R.P.
MURRAY
GENERAL CONTRACTOR

Greensboro Coliseum Complex
1921 Gate City Boulevard
Greensboro, NC 27403
Attn: Mike Purdue

Re: Value Engineering for Parking Lot Improvements Project

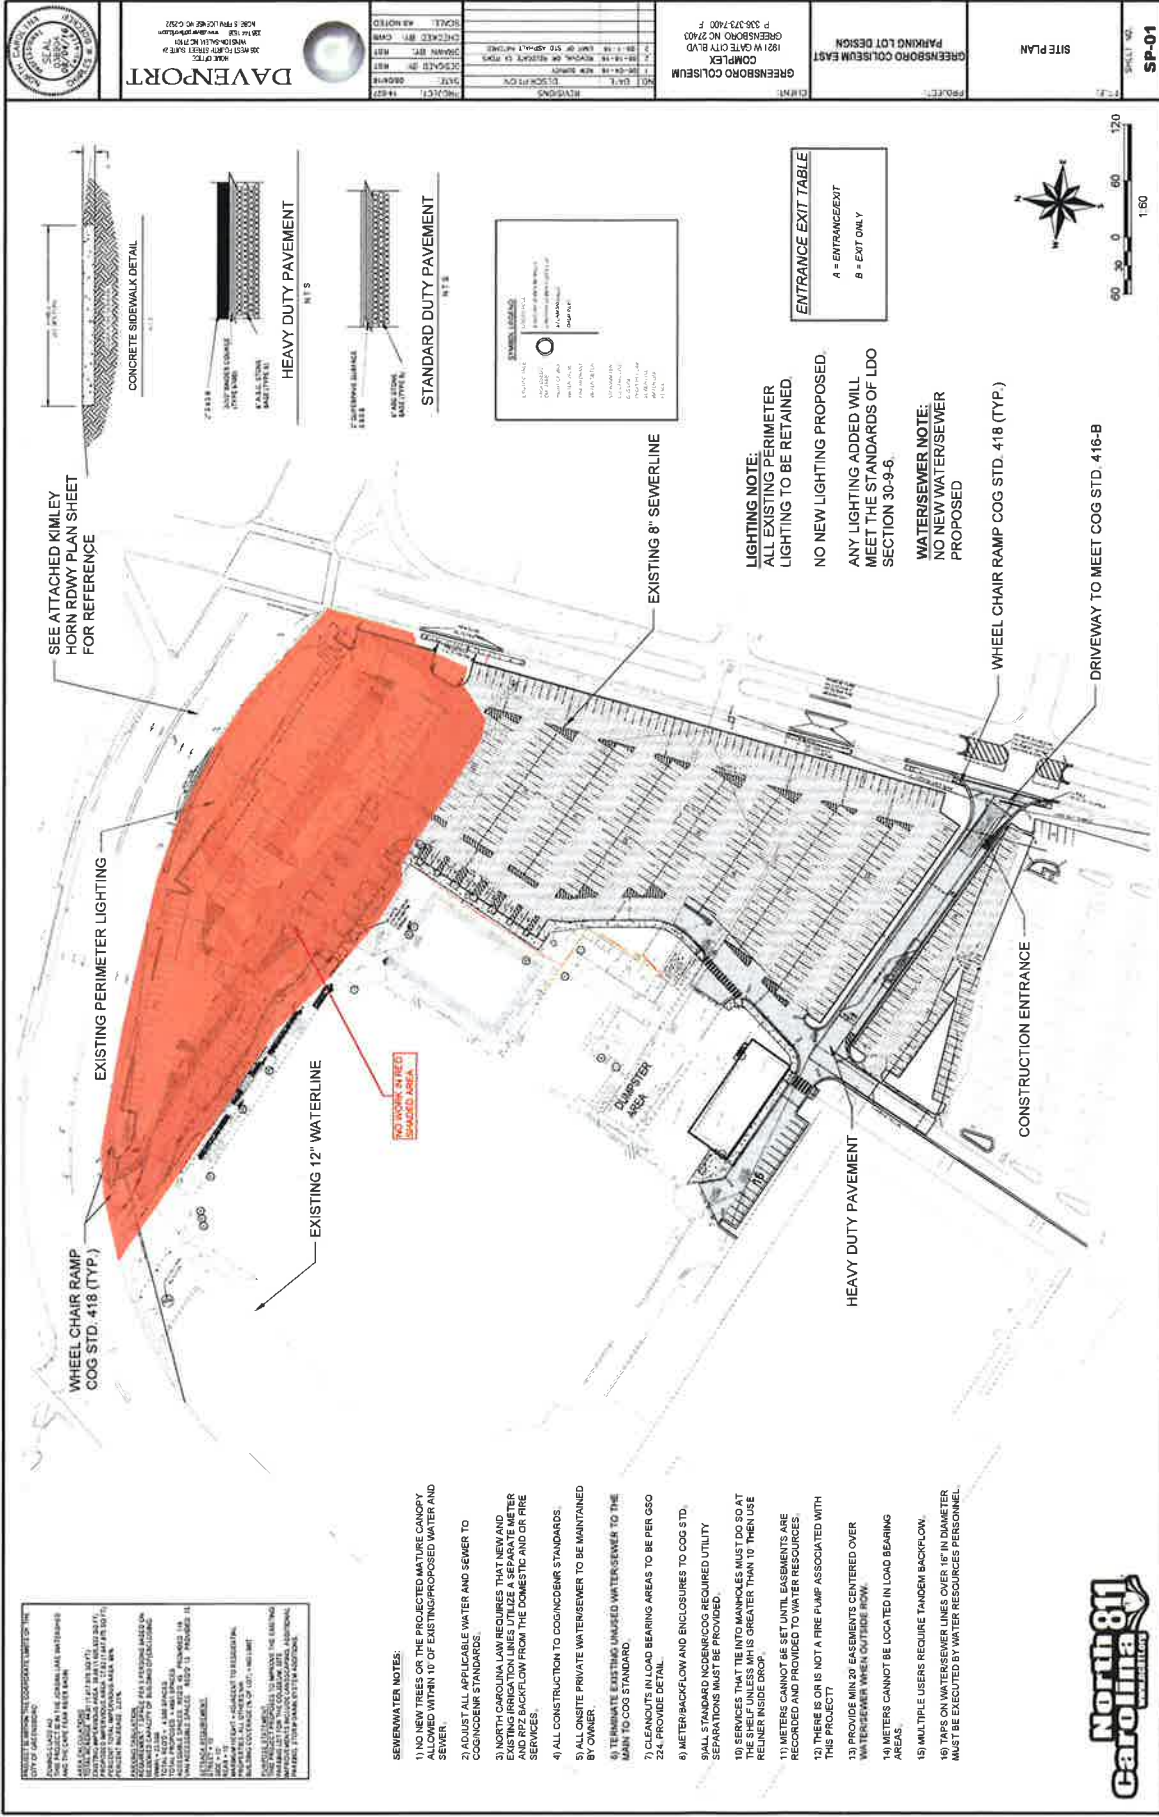
| 1. Remove All Scope in North Portions of Existing Lot: | deduct | \$250,000 |
| a. New work to terminate at existing curb as shown on the attached mark-up. | | |
